SITE DEVELOPMENT PLAN
CHICK-FIL-A POWERS & PALMER

PCD FILE # PPR2521

SITE DEVELOPMENT PLAN

CHICK-FIL-A
POWERS & PALMER PARK

SITE PLAN

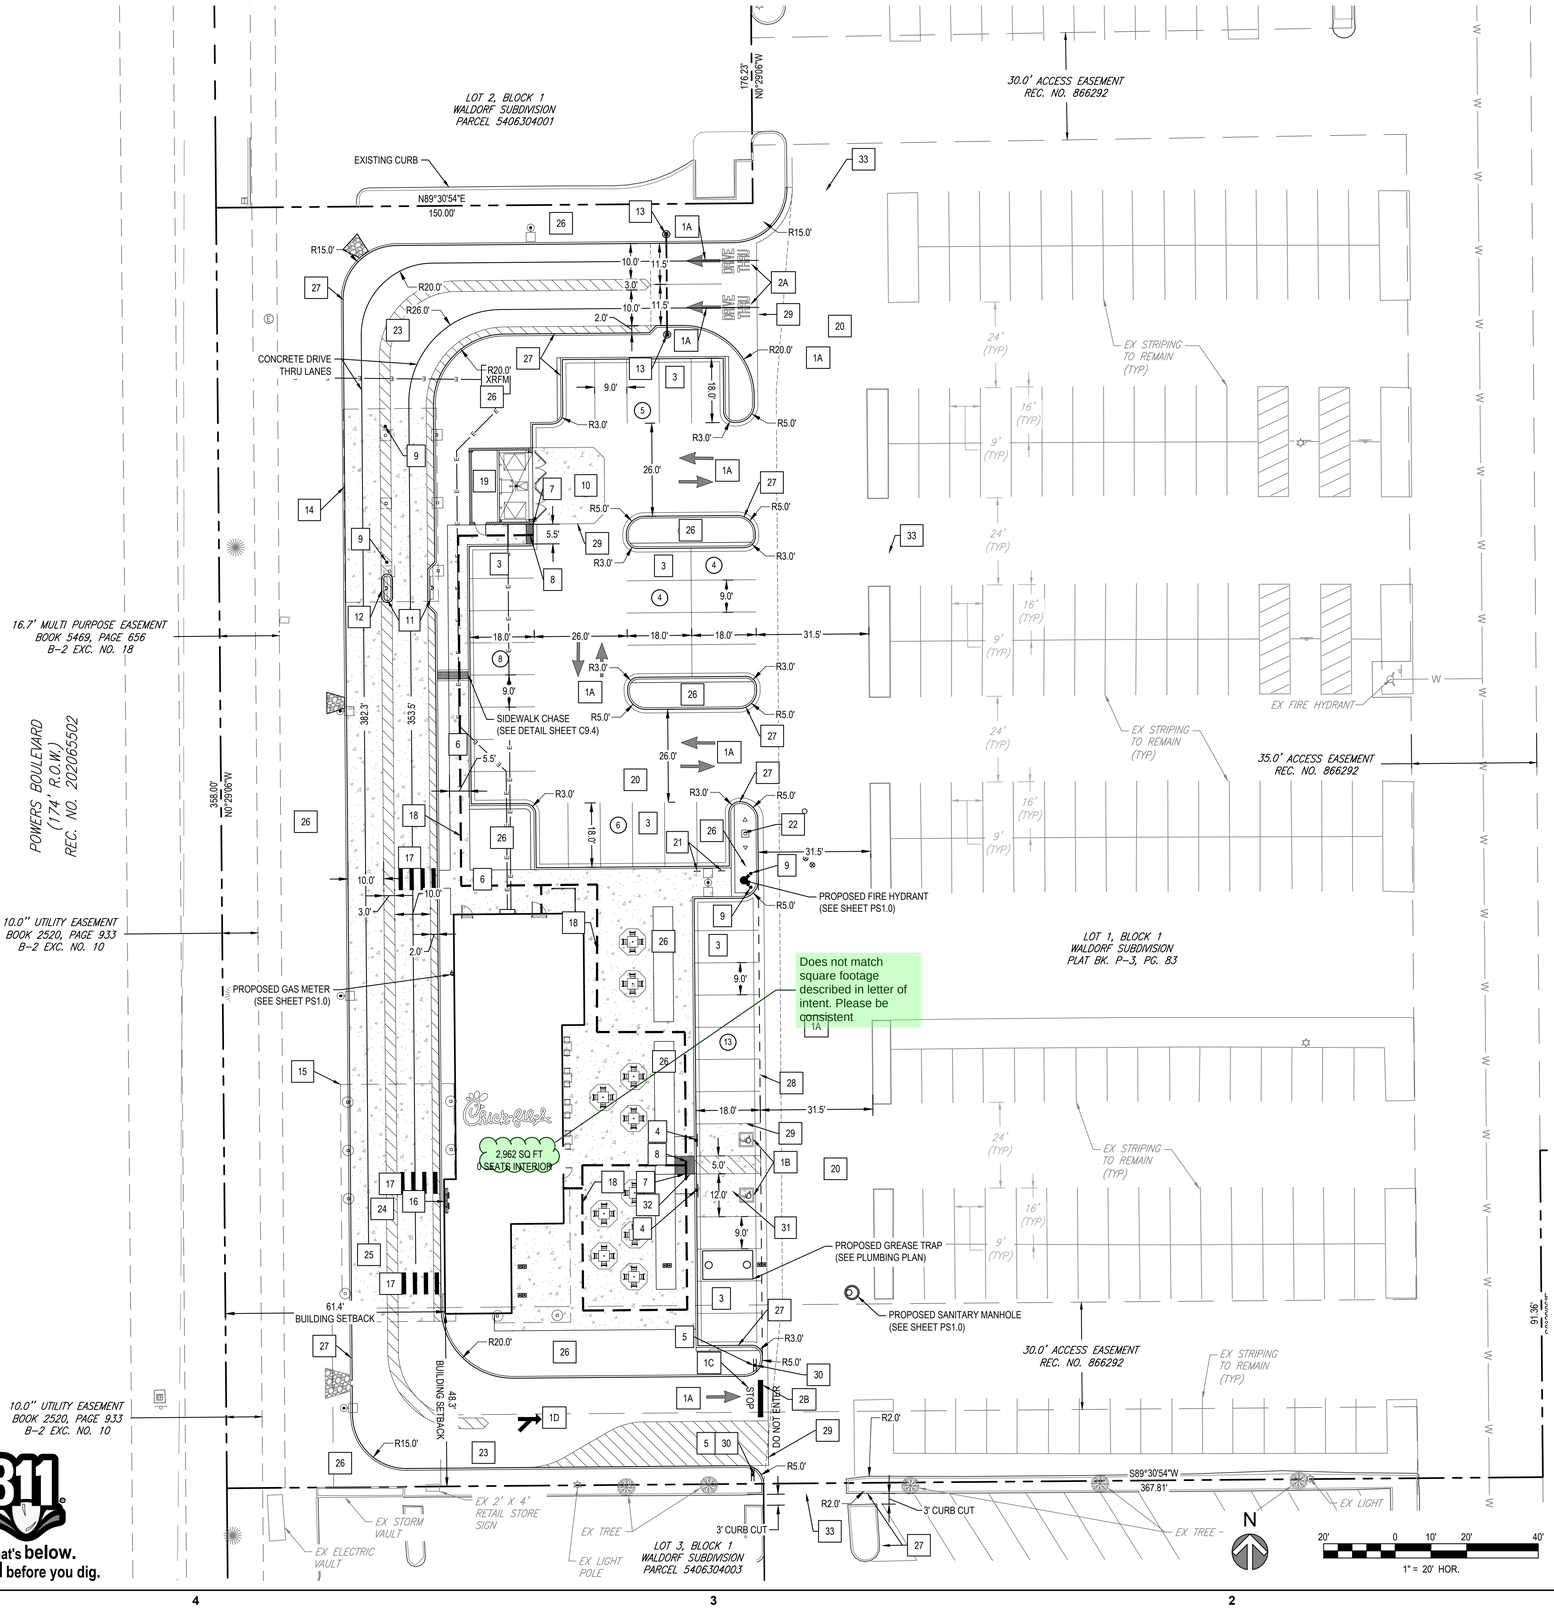
Does not match square footage described in the letter of intent. Please be consistent.

1 LANDSCAPE PLAN
SCALE: 1"= 30'

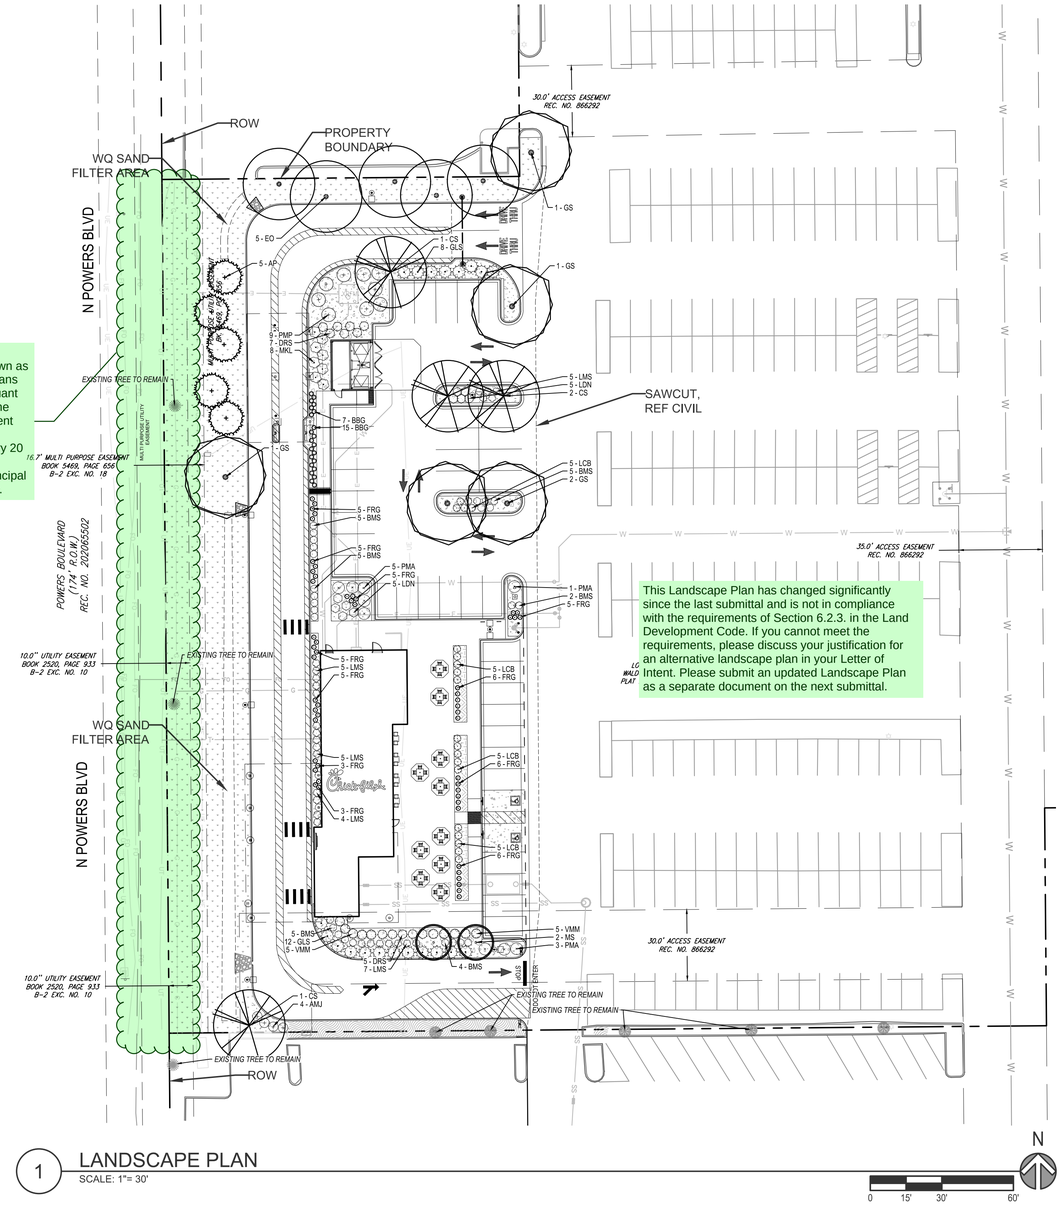
This property boundary is shown as 385 ft in other plans in this set. Pursuant to Table 6-1 in the Land Development Code, 1 tree is required for every 20 feet along an Expressway/Principal Arterial roadway.

This Landscape Plan has changed significantly since the last submittal and is not in compliance with the requirements of Section 6.2.3. in the Land Development Code. If you cannot meet the requirements, please discuss your justification for an alternative landscape plan in your Letter of Intent. Please submit an updated Landscape Plan as a separate document on the next submittal.
